# TOWN OF CORTLANDT PLANNING BOARD

**WORK SESSION.....MARCH 4, 2025 6:00 PM**

**MEETING AGENDA.....PLANNING BOARD  
TOWN OF CORTLANDT  
6:30 TUESDAY EVENING\*  
MARCH 4, 2025**

SHEET 1 OF 5

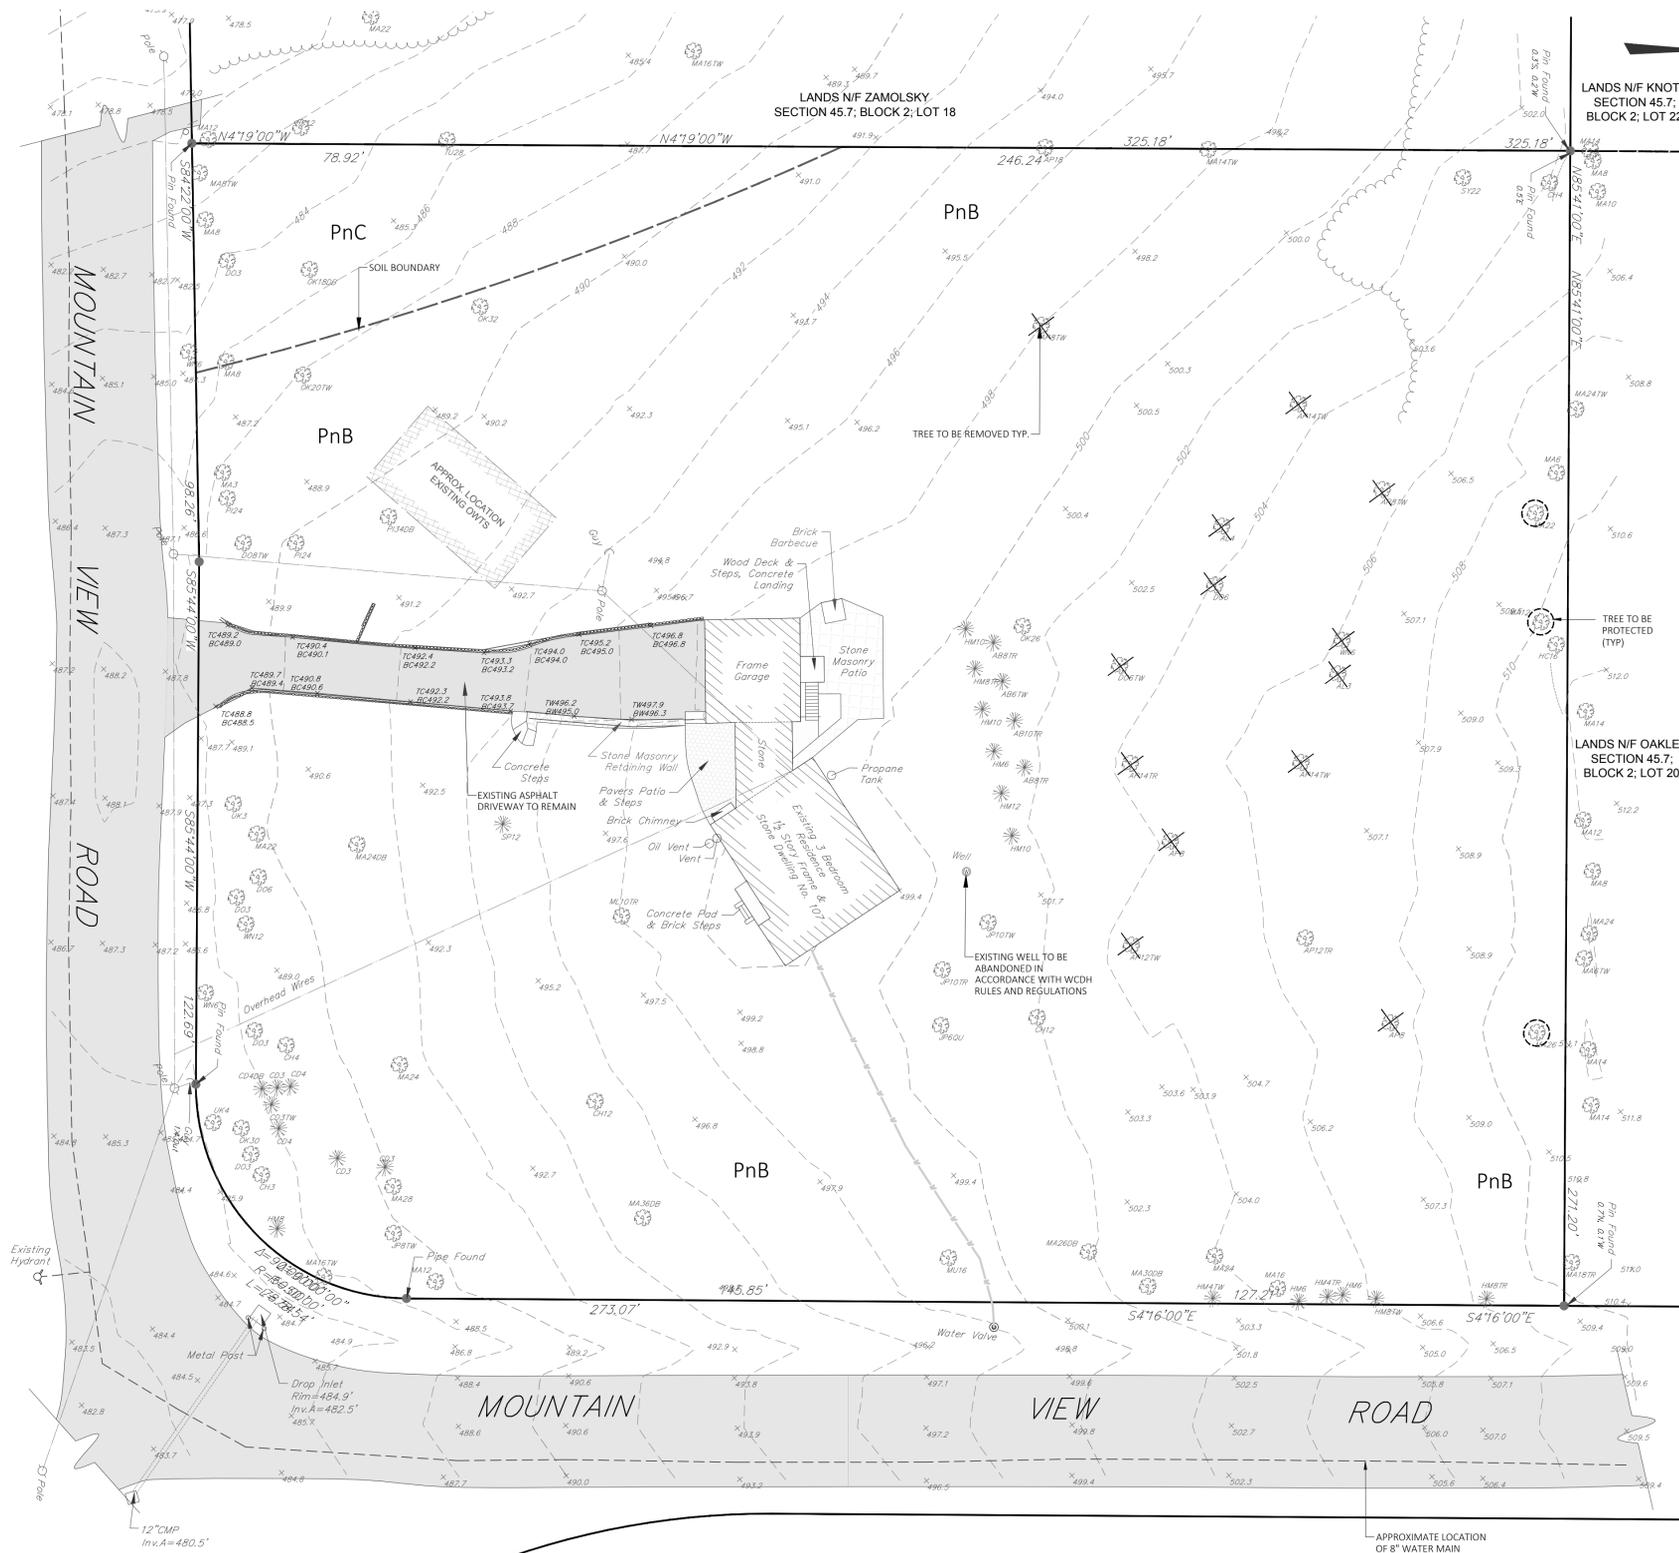
1. Sheet 1 of 5 – In accordance with Chapter 265 Subdivision of Land, please provide names of all adjacent property owners to include lot, block and section number.

2. Sheet 1 of 5 - Please provide a tree protection detail and delineate the trees to be protected during construction.

3. Sheet 1 of 5 – In accordance with Chapter 265 Subdivision of Land, please provide locations of school, fire districts, and other special district lines within the vicinity of the subdivision.

SHEET 2 OF 5 **SP-2.1**

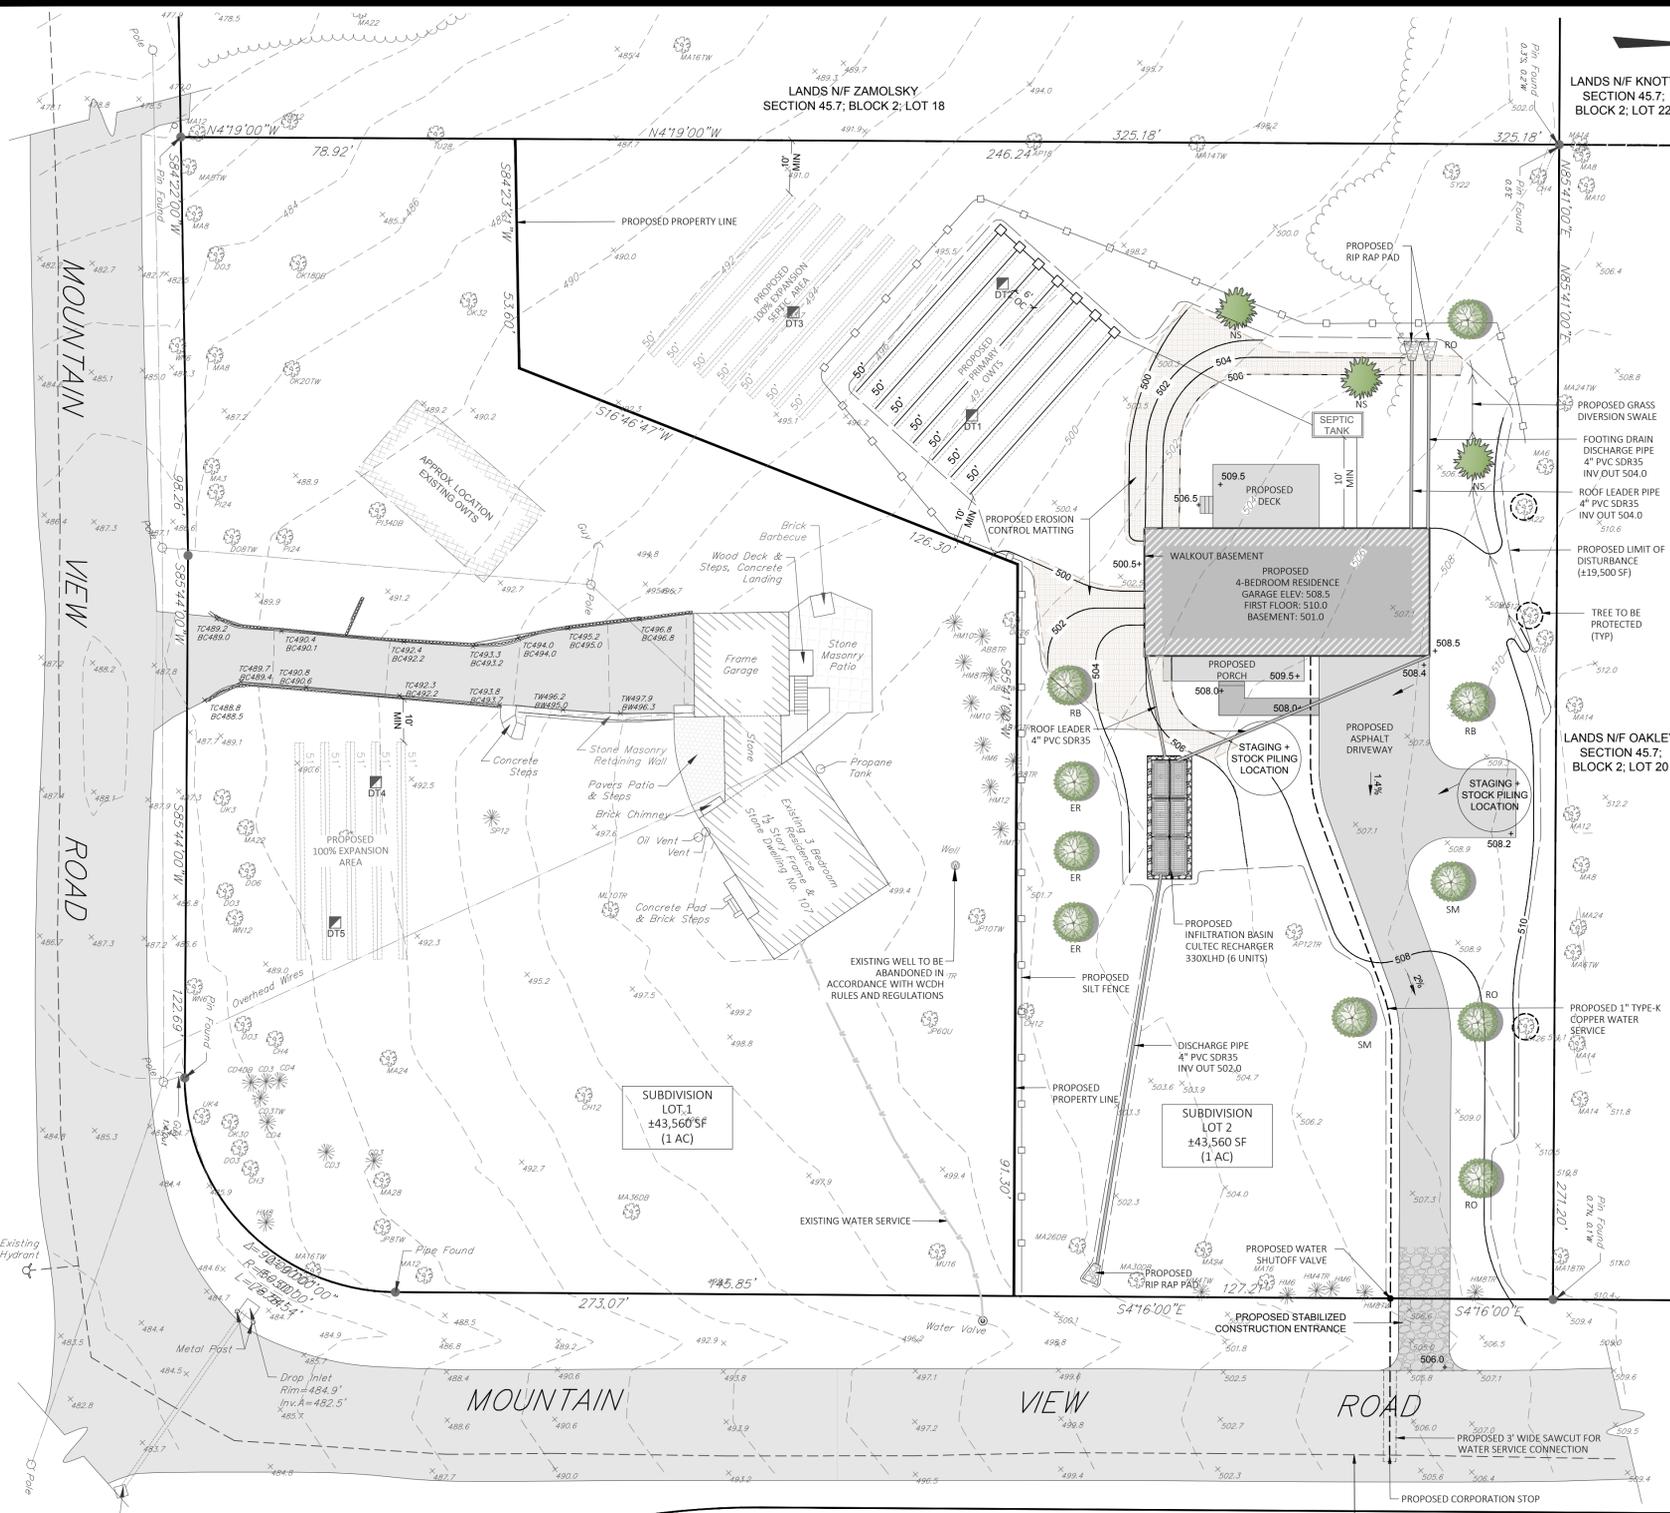
4. Sheet 2 of 5 – Provide delineation of saw cut within the Mountain View Road for the water line.

5. Sheet 2 of 5 – Please provide the following notes on the plan:
  - a. Permittee is to maintain work zone traffic control plan in accordance with Section 104 of Highway Law, while working within the Town Right-of-Way.
  - b. Road Closures are not permitted.
  - c. Overnight excavation will not be permitted.
